PITT STREET NORTH OSD REQUEST FOR ADDITIONAL INFORMATION STAGE 1 MODIFICATION (SSD 8875 MOD 1) & STAGE 2 (SSD 10375)

This letter responds to the request for additional information dated 4 February 2021 in relation to the above applications for the Pitt Street North Over Station Development (OSD).

Figure 1: Envelope Protrusions – Typical Tower Levels

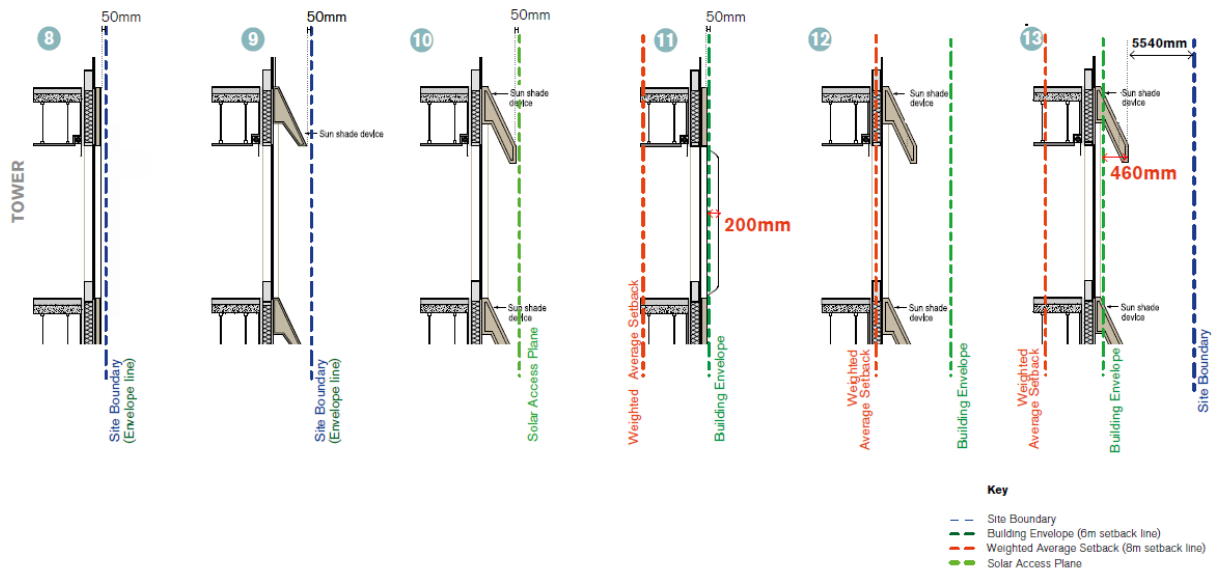
“Clarify the extent of the proposed projections beyond the approved building envelope. In particular, the extent (if any) of the proposed sunshades on the tower encroaching on the required minimum 6 metre setback along Castlereagh Street.”

Figure 1 and **Figure 2**, illustrates the proposed tower sun shading projections in relation to the building envelope (6m setback line), weighted average setback and site boundary. No building elements (including sun shading devices) project beyond the solar access plane.

Following receipt of the Departments Pitt Street North OSD Request for Additional Information request, it was identified that the projection to the south eastern tower facade (Figure 1 and Figure 2 Location 13) was excluded from Stage 1 MOD Report and Stage 2 SSD EIS (and accompanying Architectural Design Reports) in error.

North	East Castlereagh Street	South Park Street	West Pitt Street
Podium	0mm	210mm	410mm	210mm
Tower	0mm	460mm*	200mm	0mm

It is therefore requested that Stage 1 SSD 8875 MOD 1 be updated to accurately reflect the extent of protrusions contained in Table 1 above. As such, wherever the detailed projection extents are quoted

- *A maximum 460mm projection from the eastern façade; and*
- *A maximum 200mm projection from the southern façade.*
